From: Tekia Govan
Sent: Thursday, October 16, 2008 3:38 PM
To: STPCOL
Subject: FW: Preliminary Info.- STP COLA Chap 2 - RAI Conference Call and November 6 Meeting in Rockville
Attachments: Preliminary list of information needs relative to the STP COLA FSAR Chapter 21.doc

From: Tekia Govan
Sent: Tuesday, October 14, 2008 6:28 PM
To: 'Bense, Richard'
Subject: Preliminary Info.- STP COLA Chap 2 - RAI Conference Call and November 6 Meeting in Rockville

The following table represents a draft list of discussion items that will be discussed during the safety site audit for the STP Units 3 & 4 COLA FSAR Chapter 2. Additional items or changes may be added to the existing list, based on discussion and review.

Preliminary Information Needs for the STP Safety Site Audit

Figure 1
STP Stability Class Frequency Distributions

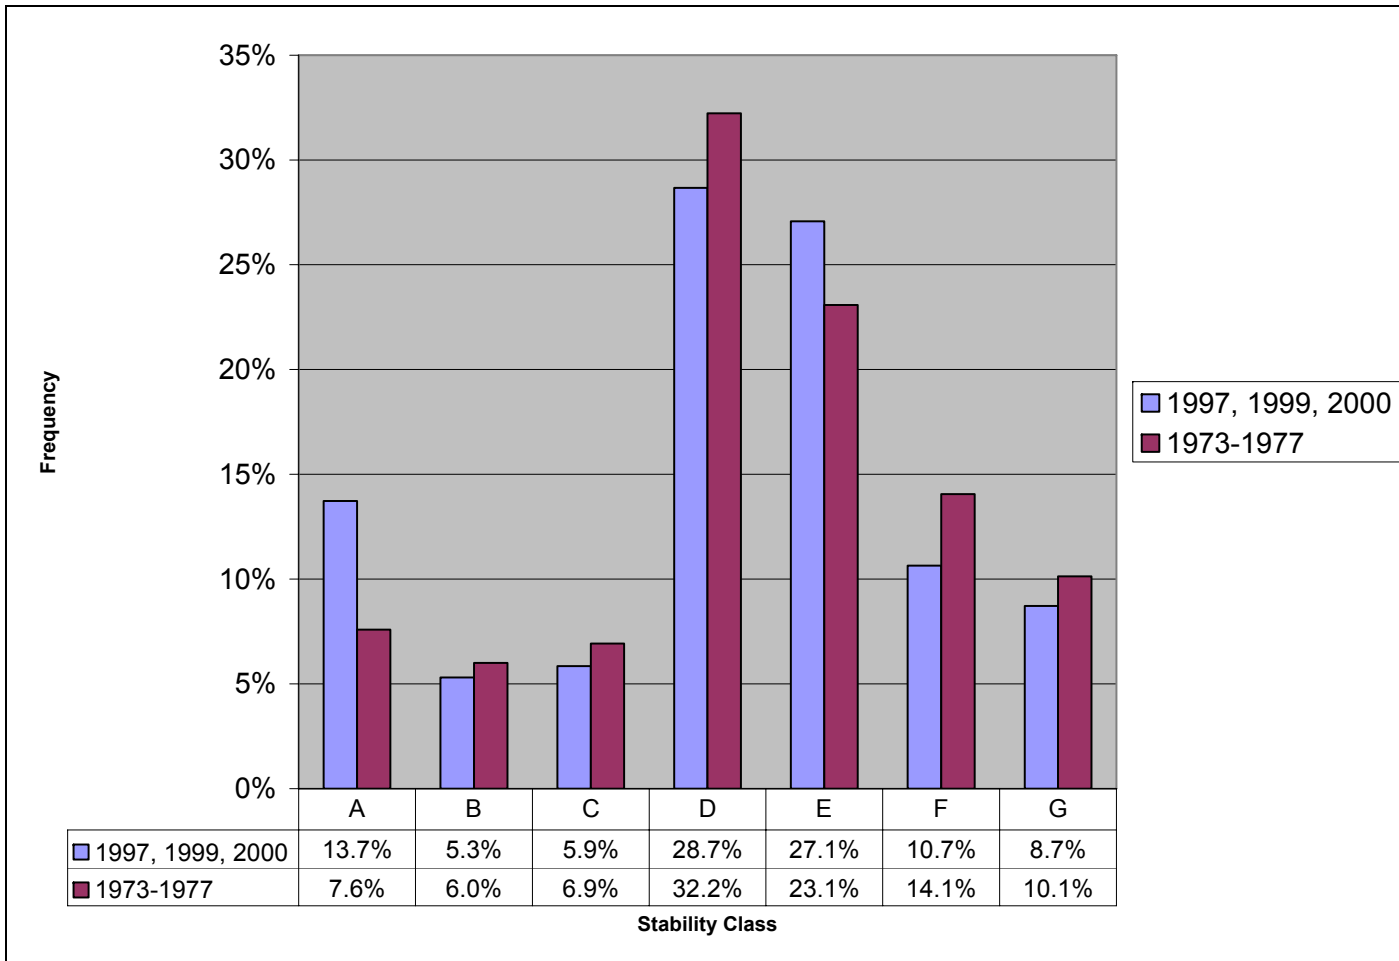
23.	2.3S3.4.1.2	Meteorology	Please explain the 6% increase of onsite A stability class frequency from the original data set (1973-1977) to the current (1997, 1999, and 2000) data set as shown in FSAR Table 2.3S-20 (see Figure 1).	Brad Harvey
